Access Compliance Report

Public Rights-of-Way

Intersection ID: 2928	Main Street: PROSPERITY_CHURCH_RD	Cross Street: RIDGE_RD	Location: SW
ADA ID: 95CBF1806BCC	Ramp Type: PerpDiag	Initial Pass/Fail: Fail	Overall Compliance: No
Severity Score: 33.75			
Codes/Mitigation Info/Possible Solution		Field Measurements/Component Compliance

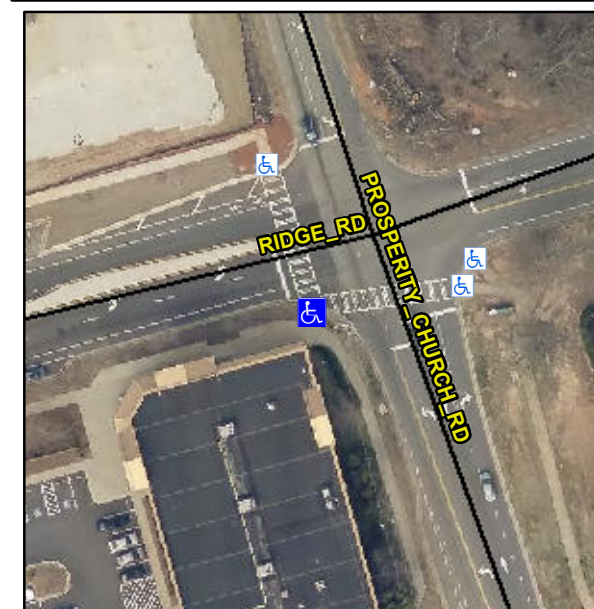
R304.5.1, R304.2.2

Compliance	Description	Data	Compliance	Description	Data
N/A	Ramp Length (in)	98.0	No	Ramp Slope (%)	13.9
No	Ramp Width (in)	41.5	Yes	Ramp XSlope (%)	1.2
N/A	Flare Type LT	N/A	N/A	Flare Type RT	N/A
N/A	Flare Slope LT (%)	N/A	N/A	Flare Slope RT (%)	N/A
N/A	Flare Traversable LT?	N/A	N/A	Flare Traversable RT?	N/A
N/A	Landing Length (in)	N/A	N/A	DWS Provided?	N/A
N/A	Landing Width (in)	N/A	N/A	DWS Contrast?	N/A
N/A	Landing Slope (%)	N/A	N/A	DWS Length (in)	N/A
N/A	Landing X Slope (%)	N/A	N/A	DWS Full Width?	N/A
N/A	Landing Curb? (Y/N)	N/A	N/A	DWS Offset (in)	N/A
N/A	Shared Landing?	N/A			
N/A	Gutter Ponding?	N/A	N/A	Gutter Slope (%)	N/A
N/A	Gutter Lip Ht (in)	N/A	N/A	Gutter X Slope (%)	N/A
N/A	Painted X Walk1?	Yes	N/A	Painted X Walk2?	Yes
	X Walk 1 Direction	To E		X Walk 2 Direction	To N
N/A	X Walk 1 Width (in)	111.0	N/A	X Walk 2 Width (in)	122.0
	X Walk 1 Slope (%)	2.9		X Walk 2 Slope (%)	3.8
	X Walk 1 X Slope (%)	3.8		X Walk 2 X Slope (%)	4.1

Remove & Replace Curb Ramp With Two New Directional Ramps or Equivalent.
